**CITY OF ESSEX JUNCTION  
DEVELOPMENT REVIEW BOARD  
PUBLIC HEARING AGENDA (REVISED)  
SEPTEMBER 21, 2023  
6:30 P.M.**

**Subject:** 8 Railroad Street –Conceptual Site Plan Review for proposed 39-unit residential apartment building

**To:** Development Review Board  
**From:** Jennifer Marbl, City Planner  
**Meeting Date:** 09/21/2023  
**Subject:** Conceptual Plan Pearl Street Place by GVV Architects Inc., for Robert Paroline, Owner, in the Highway Arterial District for a Planned Unit Development.  
**File:** SP#7.2023

SHEET:  
 A.0

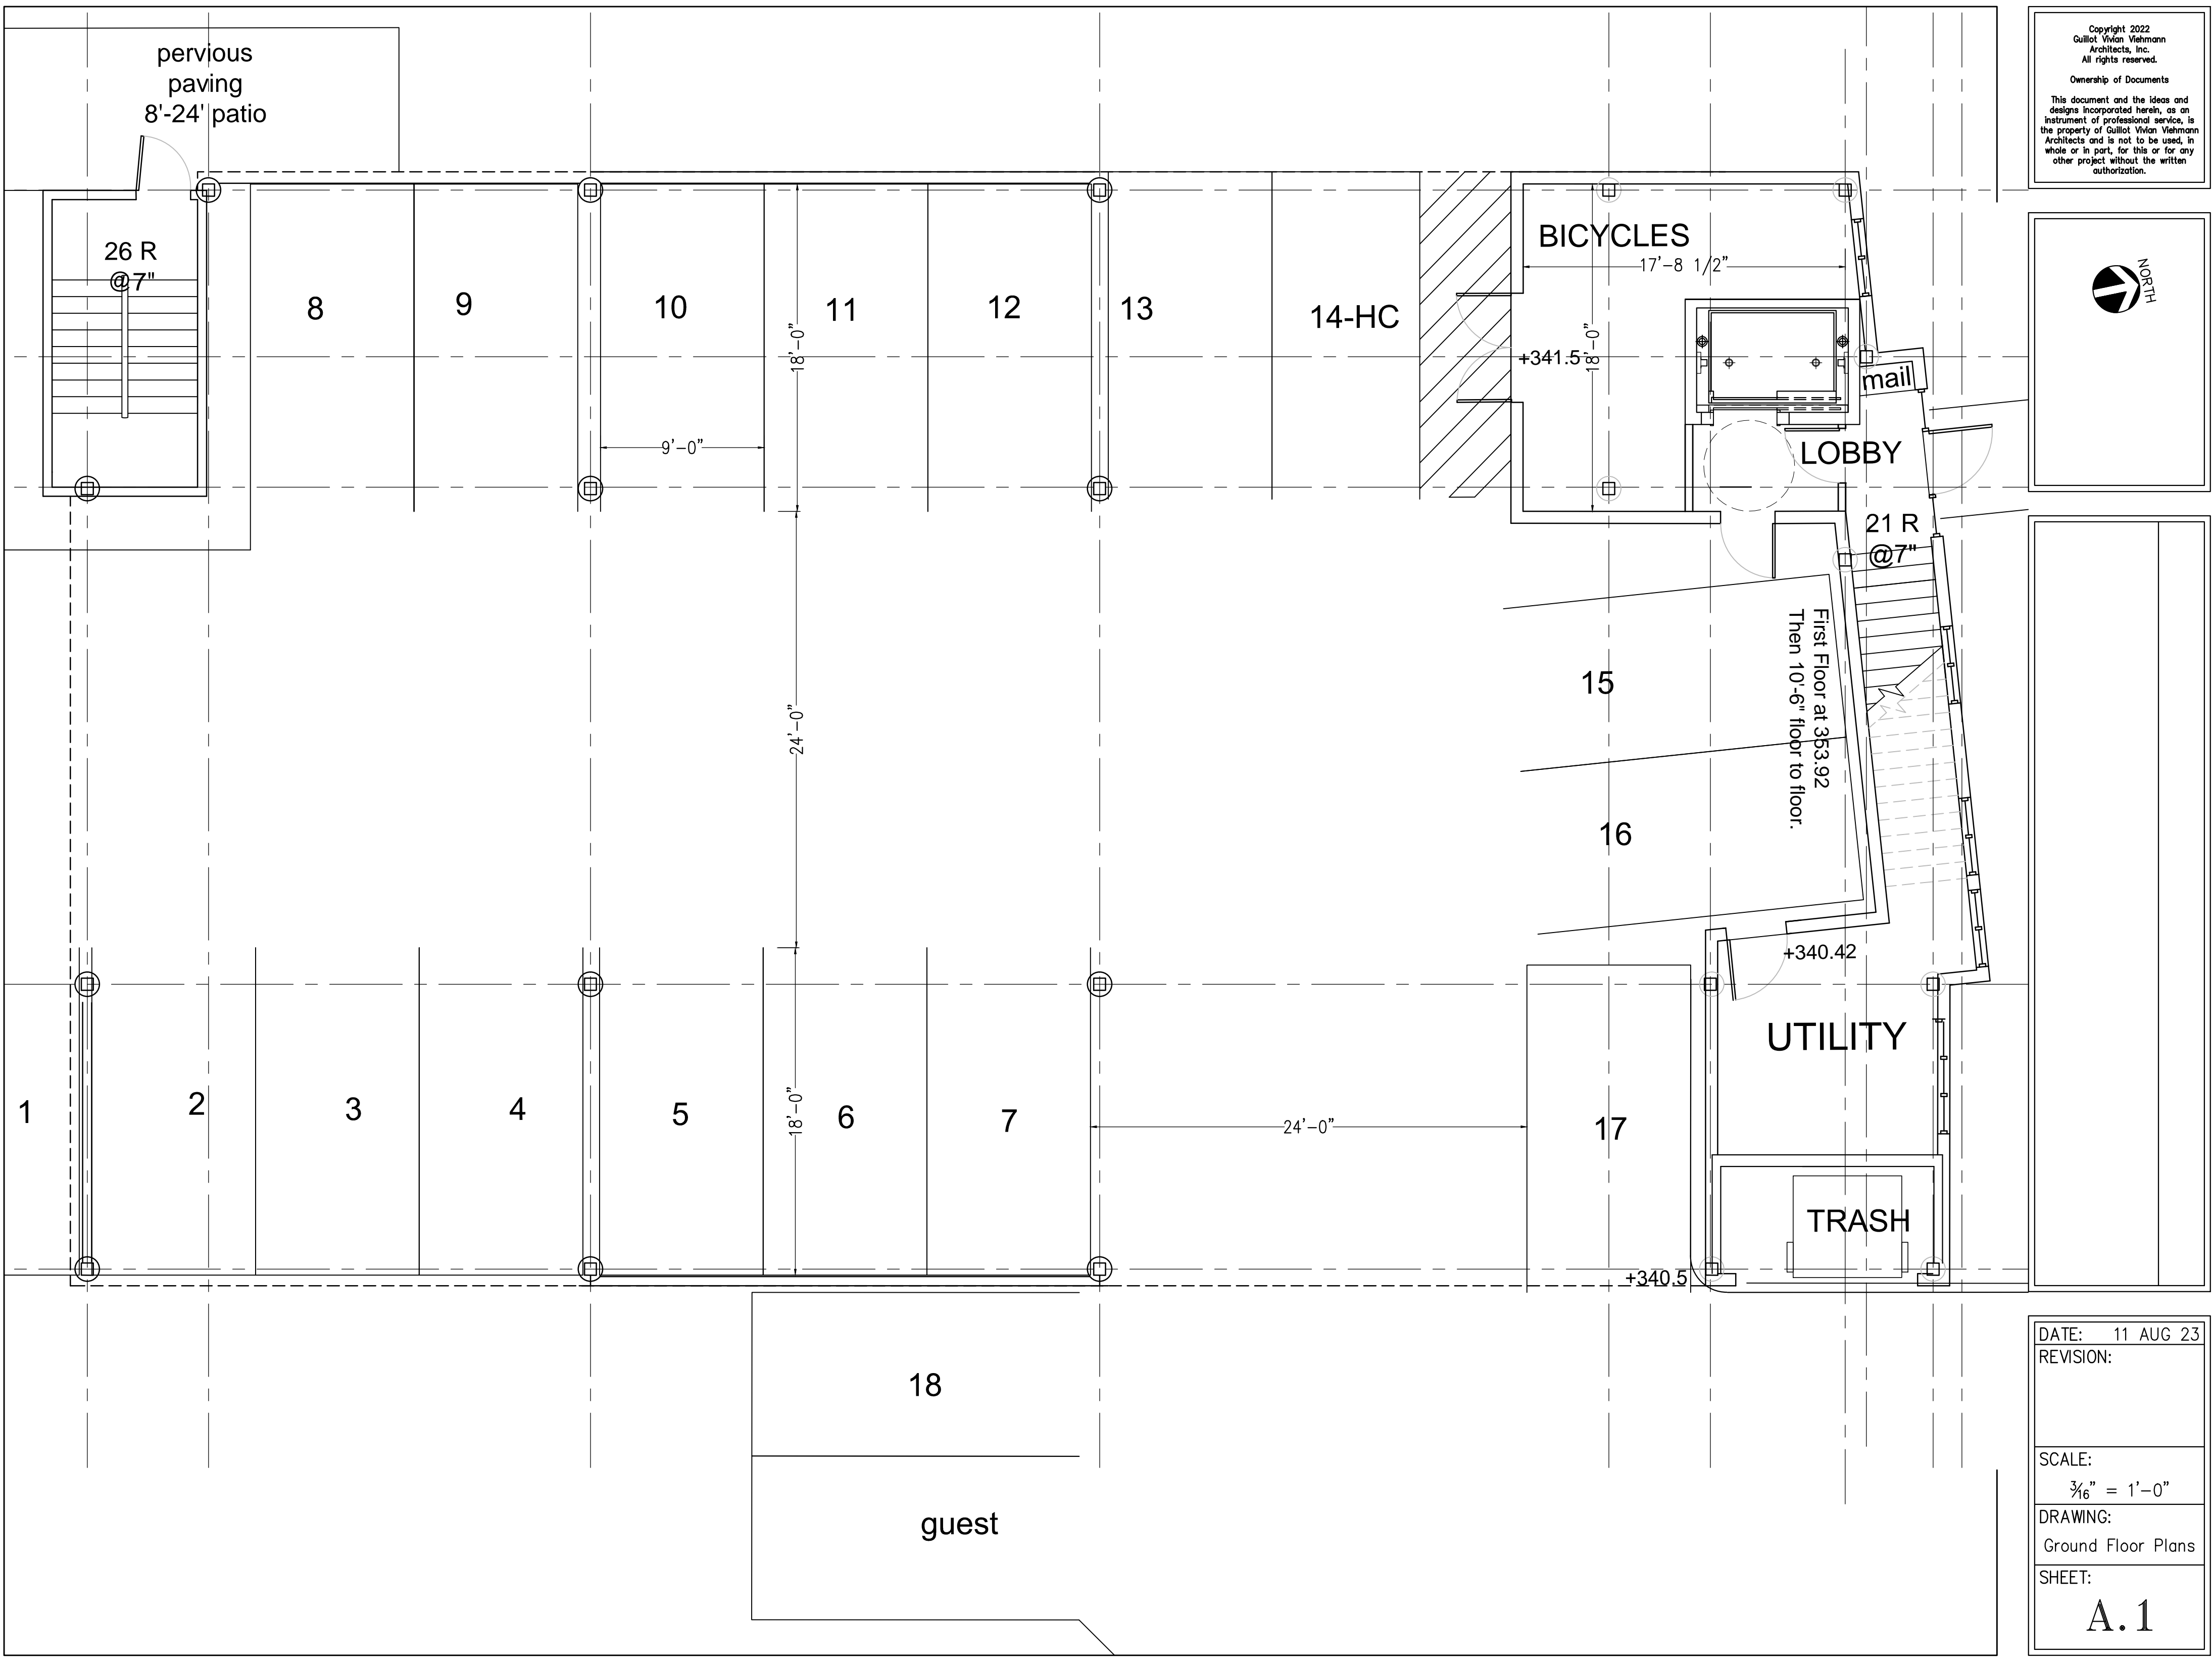
**The proposed building is exceeding the front and rear setbacks. Setback requirements could only be waived with a variance under Section 1703, or if the project is evaluated as a Planned Unit Development (PUD) under Section 511.**

The proposed development intends to use existing curb cuts, shown to be 24 feet in width on the site plan, which is in line with the requirements of the Section 705.C.2.

**The proposed building plans include a six-foot tall fence along the northwest and southwest edges of the property, with some portions extending into the front setback. The example of the type of fence intended for use can be considered transparent due to its spacing, therefore meeting the above requirements.**
